# BusConnects Dublin Core Bus Corridor Projects

## Corridor 9 – Greenhills to City Centre

### Emerging Preferred Route – Public Consultation Report 2018/2019

**MAP 4:**

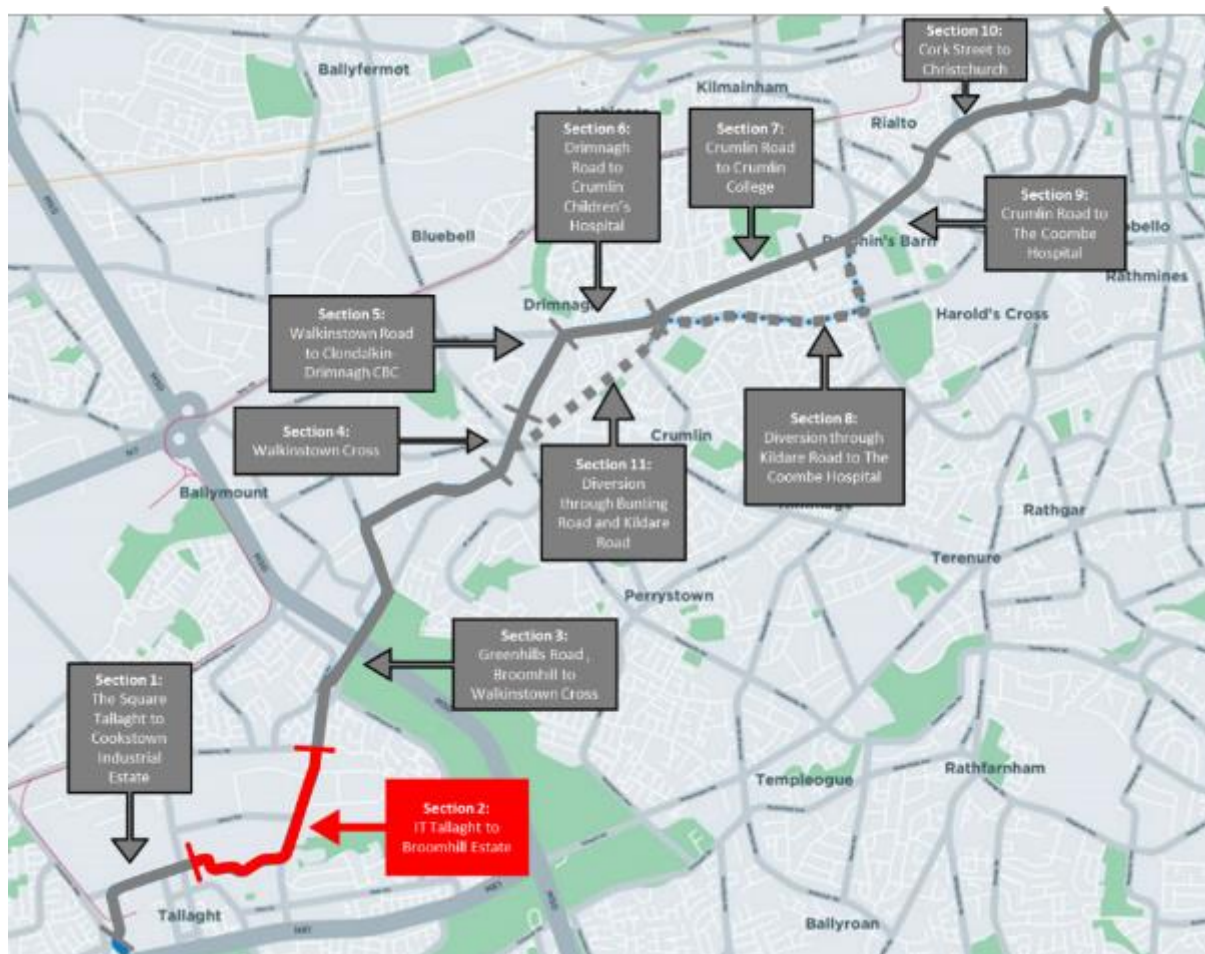
- This area is well served by various public/ private car parks, so the provision of on-street parking should be reconsidered.
- Belgard Square North should be reviewed to provide cycle tracks; could be achieved by restricting the road to local access only, with the Tallaght bypass carrying through traffic. Alternatively make the road one-way for traffic.
- Primary Route SO5 of the Greater Dublin Area Cycle Network Plan runs along Belgard Road, so a fully protected junction for cyclists should be provided at the Belgard Road/ ITT Access Road.

**MAP 8:**

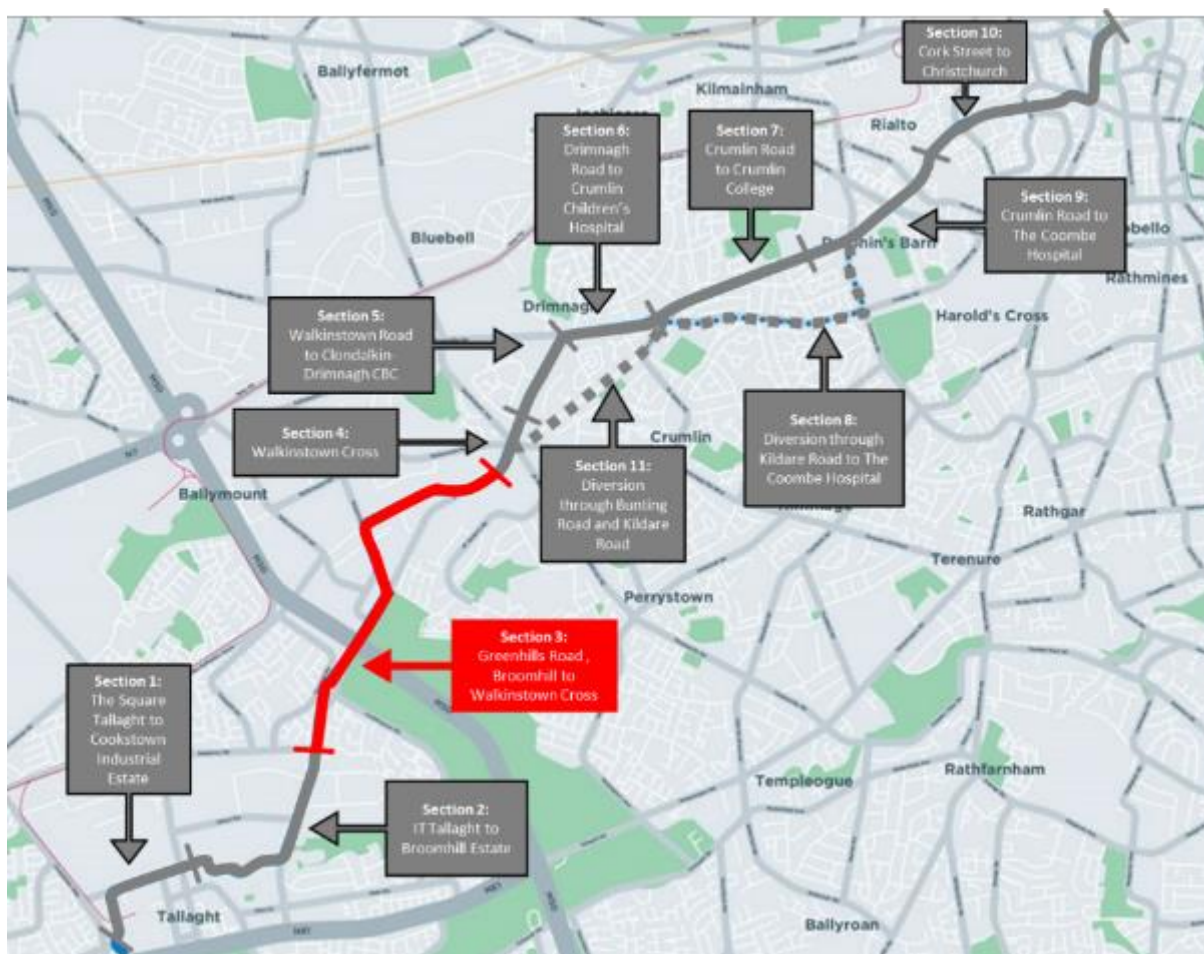
- Shared space unacceptable at Broomhill Road Junction.
- Cyclists turning left onto Mayberry Road will mount the kerb.
- Junctions should be raised and a buffer space provided between the road/ cycle track, to remove cyclists out of HGV blind spots.
- Suggestion to close one of the two entrances to Hibernian Industrial Estate to improve the overall safety of cyclists and pedestrians and reduce potential conflicts.
- Safety of and provision for right turning cyclists both into/out of Mayberry Road needs to be factored into the design.

### MAP 18:

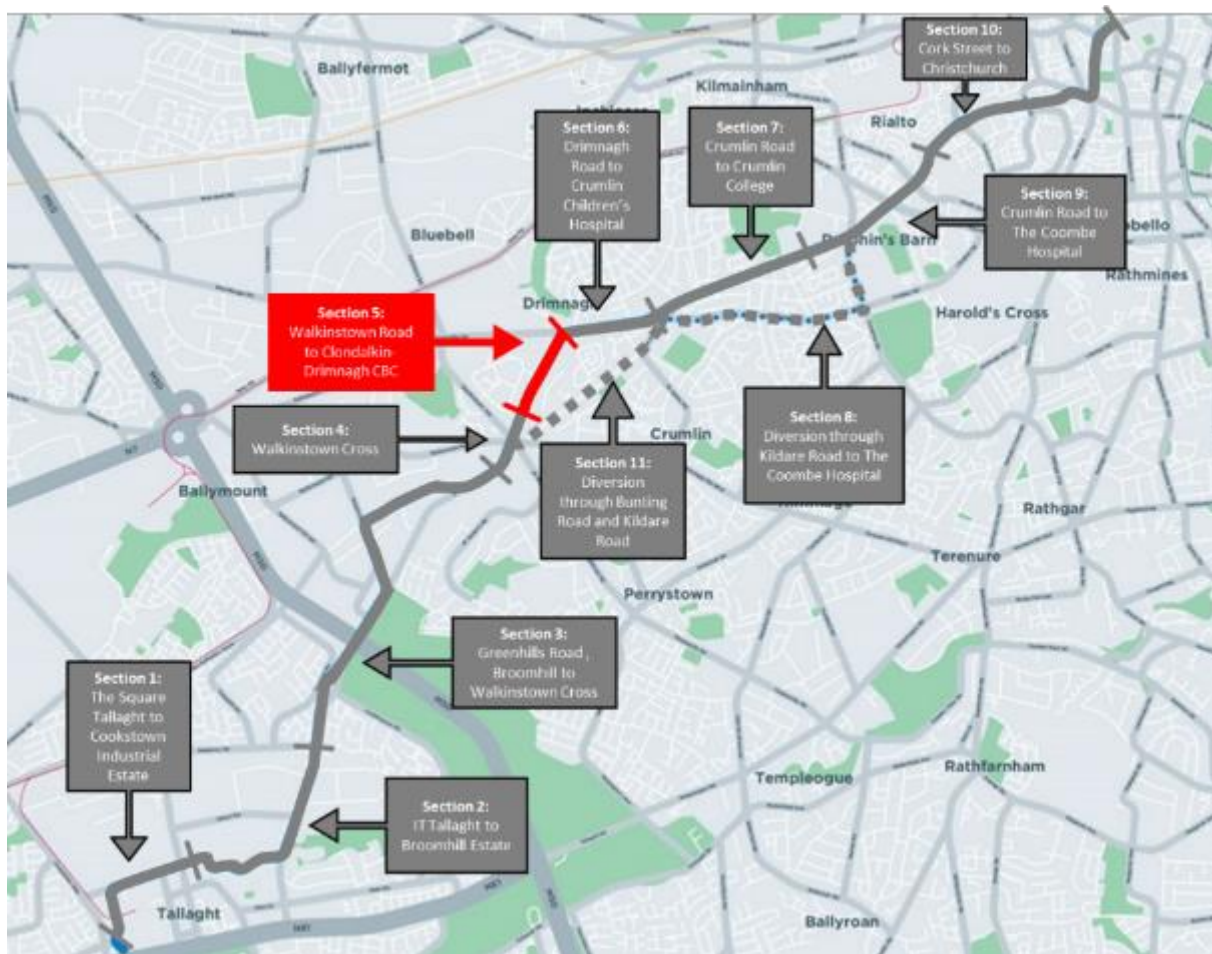
- The provision of a shared space at a roundabout is considered to be highly inappropriate, particularly Walkinstown Cross. Cyclists will be approaching pedestrians from both sides.

- Unacceptable inline bus stops.
- The cause of congestion in the area is the build-up of vehicles at this roundabout due to accessibility to M50 North, M50 South, Tallaght, South Dublin City, City Centre and West Dublin.

- All six corners of this roundabout are currently used as car parking. Land take from these could provide a Dutch Style junction.

- If cycle facilities at all arms is not feasible, at least provide a bidirectional cycle track connecting Greenhills Road to Bunting Road.
- The junction between Bunting Road and Cromwellsfort Road is not at all safe for cyclists. The outbound cycle track suddenly disappears just before the junction. Inbound cyclists also inexplicably lose their cycle track at the bend. It is not clear how an outbound cyclist on Bunting Road can re-join cycle tracks on Greenhills Road, nor how they will make a right turn.

The Layout of the Walkinstown Roundabout has been revised to include segregated cycle facilities and signalised pedestrian and cycle crossings on all arms. In addition, traffic calming ramps will be provided on the approaches to the junction to slow traffic down.

### MAP 19:

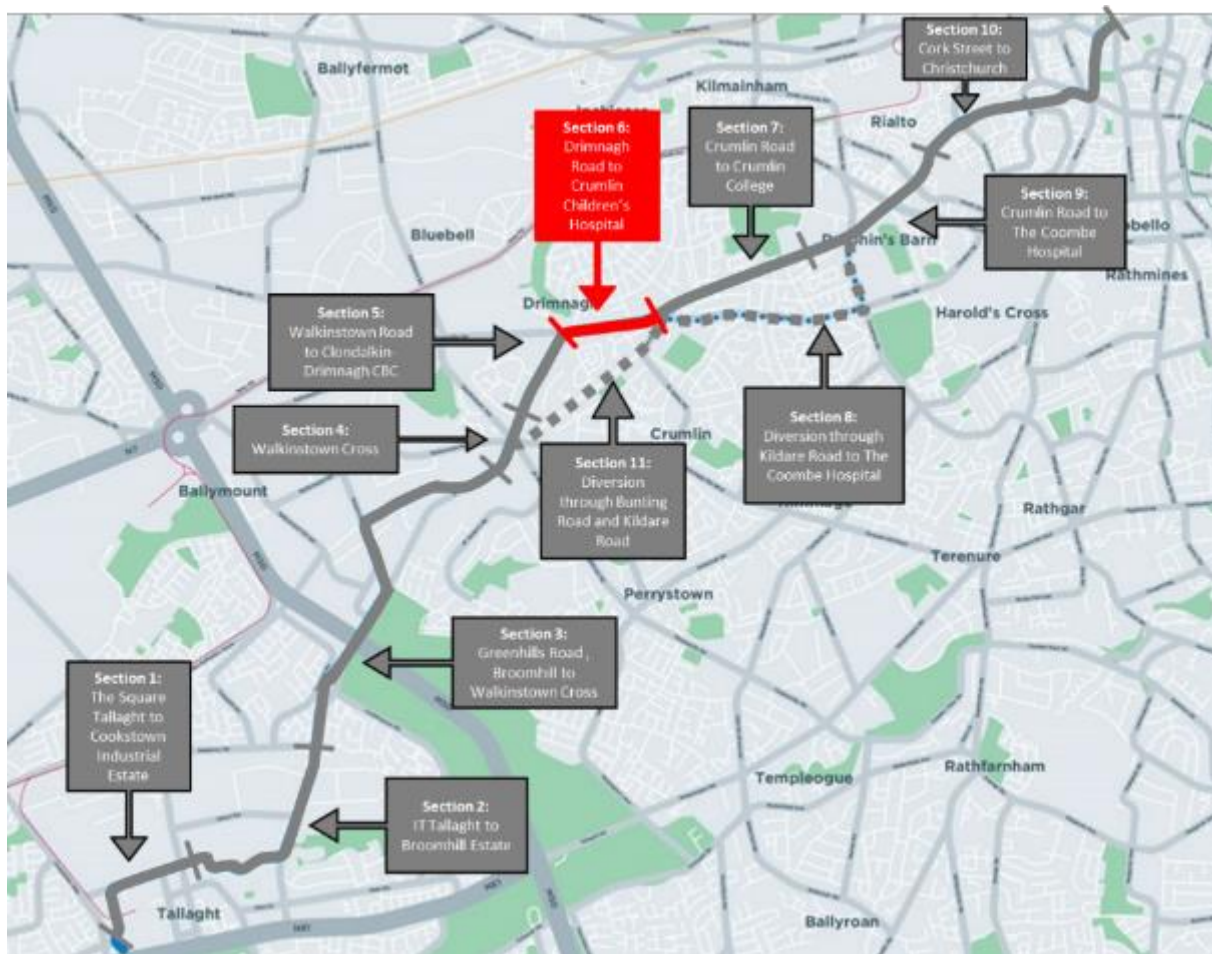
- Two additional lanes shown on NTA maps, yet only a small amount of land acquisition. This may lead to narrower footpaths which puts vulnerable pedestrians, especially those with disabilities at risk.
- The no right turn at Walkinstown/ Kilnamanagh Road may lead to excessive U-turns along Walkinstown Road.

**MAP 29:**

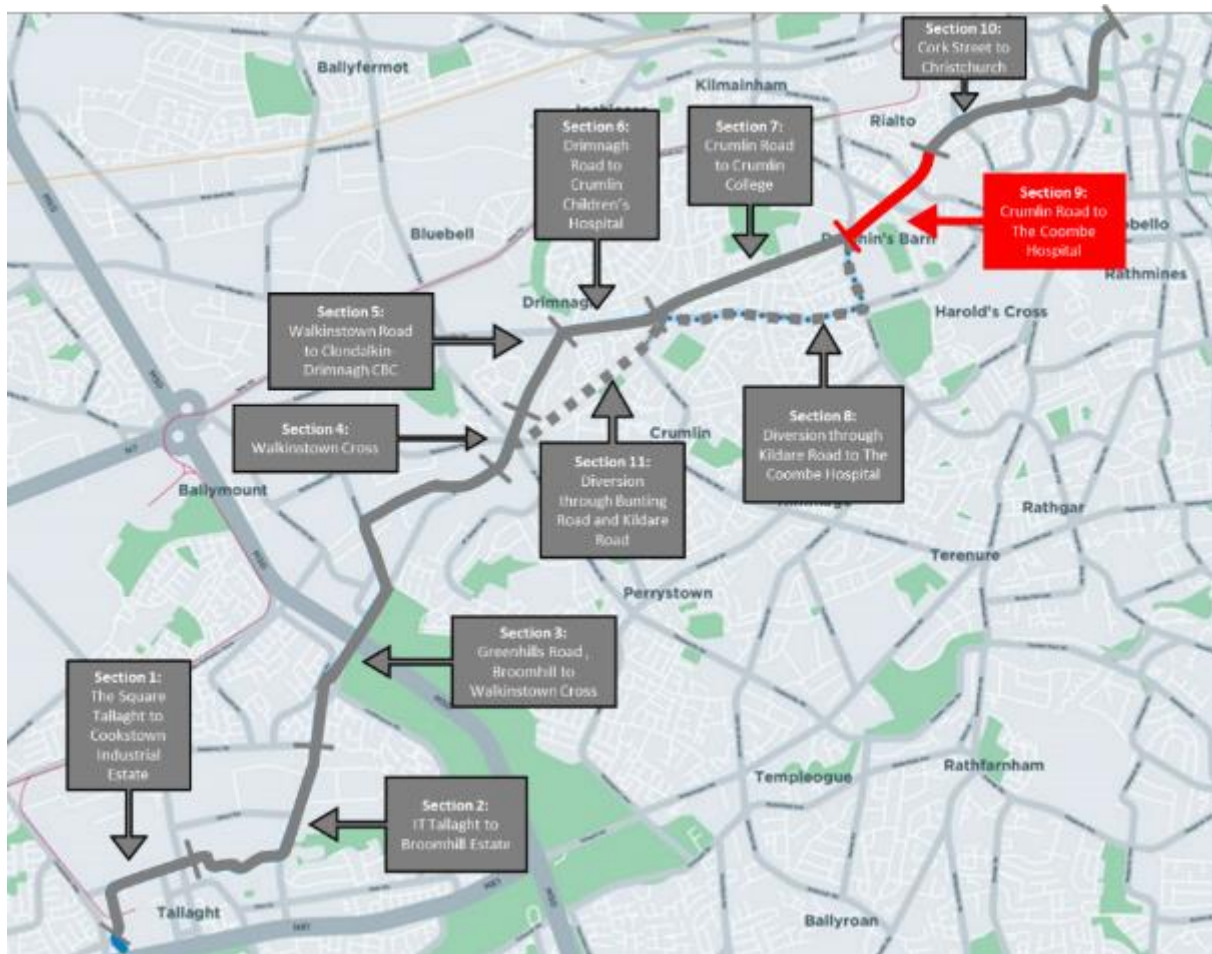
- Dangerous right turn for cyclists from Sundrive Road onto Downpatrick Road.
- Shared space at the corner of Downpatrick Road is dangerous and leads straight into an inline bus stop.

**MAP 32:**

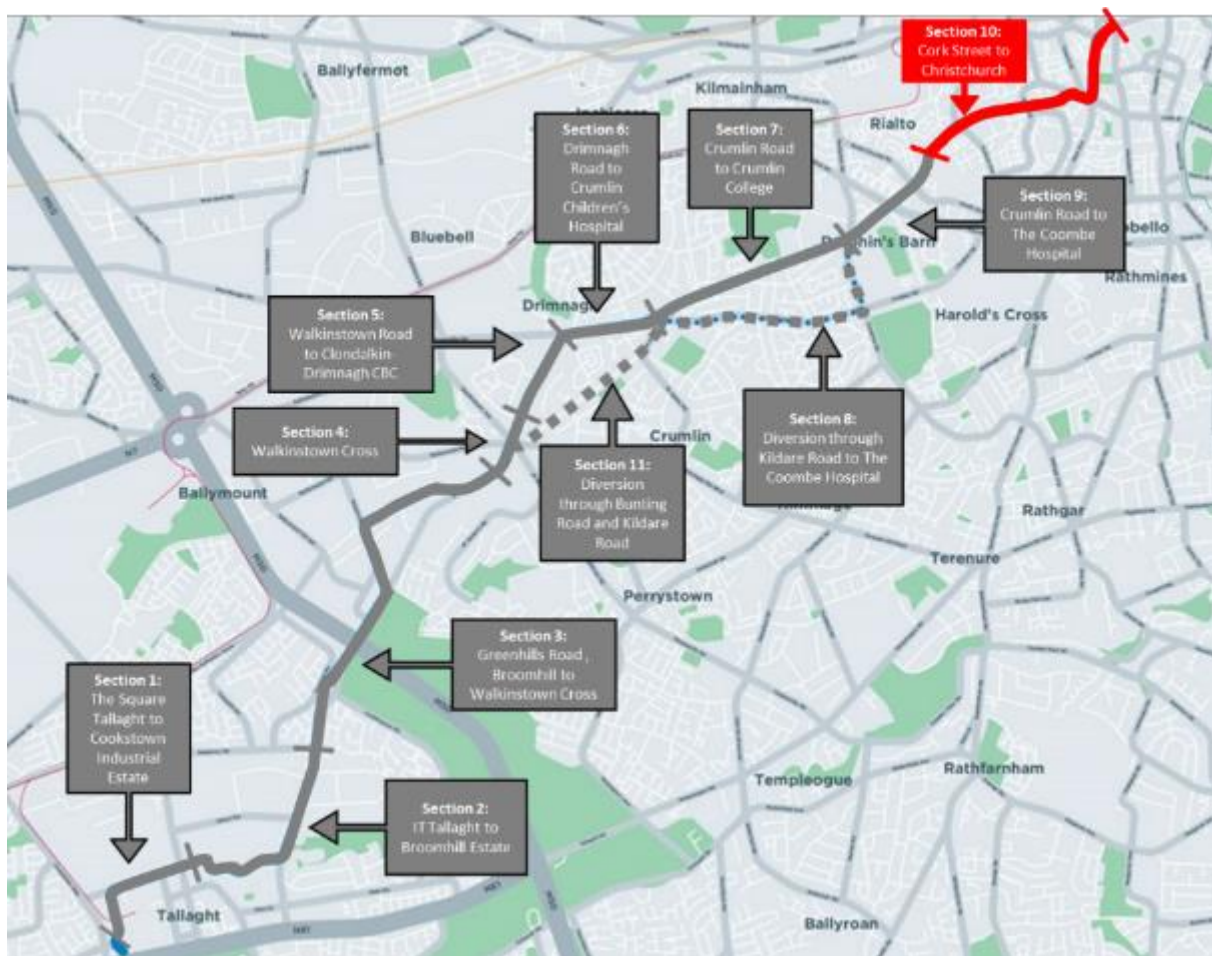
- “No left turn” implemented onto South Circular Road.
- Bike lanes need to go behind bus stops (bus stop bypasses).
- There is ample room at the South Circular Road junction to provide a Dutch Style Junction with fully segregated cycle and pedestrian facilities.
- Directly outside the Coombe, the pavement is currently always blocked by vehicles parking all four wheels on the footpath and kerbs. More aggressive parking deterrents as seen at the Wilton Terrace/ Grand Canal area should be implemented here. Grass verges and the plantation of trees would also mitigate this issue.
- The addition of an outbound traffic lane should be reversed in order to provide an inbound cycle lane instead.
